4th December 2019

I am writing to you to lodge my objection to the proposed Lindfield Learning Village Stages 2 and 3.

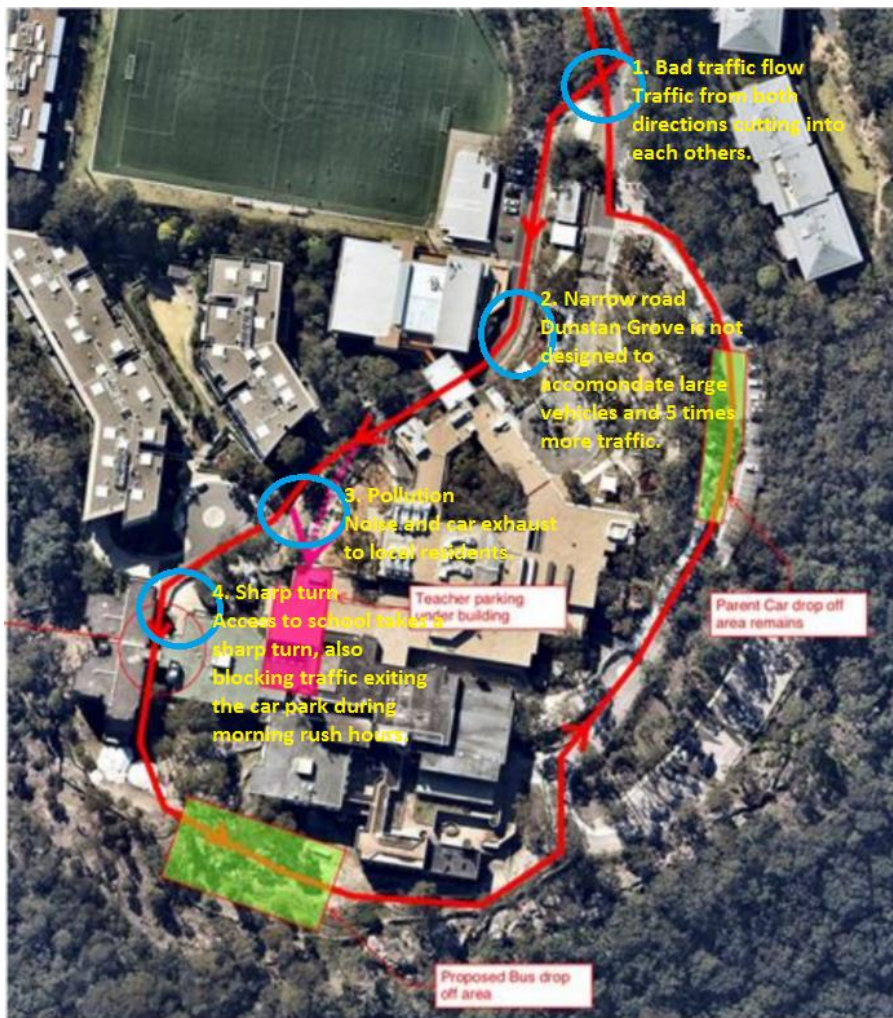
(Please refer to the picture above)

1. Currently, all traffic moves along the eastern side of the road to the school and exiting along the western side of the road. There is no obstruction to the flow. However, the proposal will see the traffic cutting into each other from both directions, hence causing a grid lock.

2. From there, the traffic pass through the parking area (before the walkover bridge) of the sport centre. Parking and leaving the sport centre will cause congestion. Also, Loop Road is a narrow road with a bending angle, a turning bus will certainly run into the other side of the road. On the top of that, this is the ONLY spot where the residents use to get to the bus stop. The existing pedestrian path is narrow and incomplete, people are forced to cross the road in order to reach to the other side of the pedestrian path.

3. The Loop Road is designed for light traffic; it has proximity the Dunstan Grove Residency. Heavy traffic brings noises and polluted air to the surrounding environment. The current number of residents is around 350, the proposal brings an additional 2100-man traffic to this area (6 times over) within rush hours twice a day.

4. Access to the school is too close to the carpark exit. Again, turning buses will cut into the carpark entrance and the exiting vehicles. Turning buses will certainly bring more noises and exhaust fumes to the surrounding. The conflict of traffic flow will cause delay for people going to work in the morning.
